Staff Report to the Plan Commission

Estates at Ravinia Meadows by Pulte

Project: 2024-0676 – Estates at Ravinia Meadows – Special Use Permit **Amendment** for a Residential Planned Development

Estates at Ravinia Meadows – Site Plan

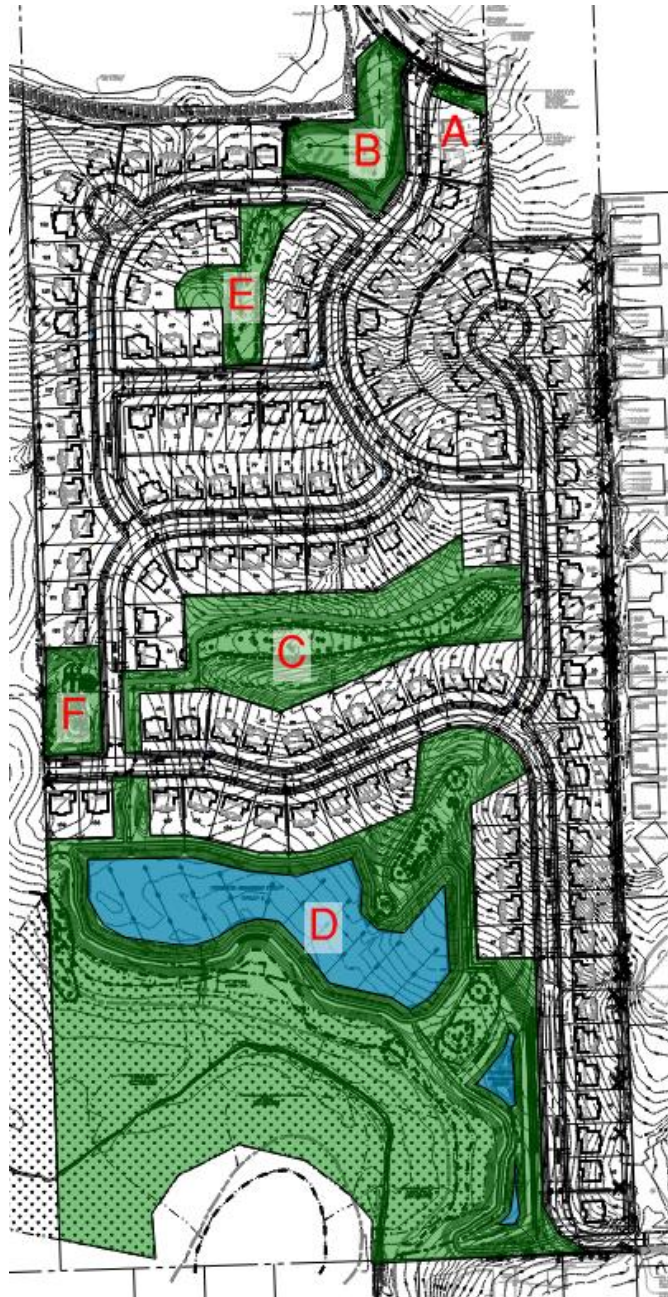
- Expansion of Outlot B to accommodate volume control for stormwater management via a bioswale for the northern portion of the Pulte project.
- Reduction in the number of housing units from 132 to 129, to accommodate expansion of Outlot B.

3 units shown in yellow have been eliminated, reducing the total number of units from 132 to 129. This allows an expansion of Outlot B which contains a bio swale providing storm water volume control for the northern portion of the site.
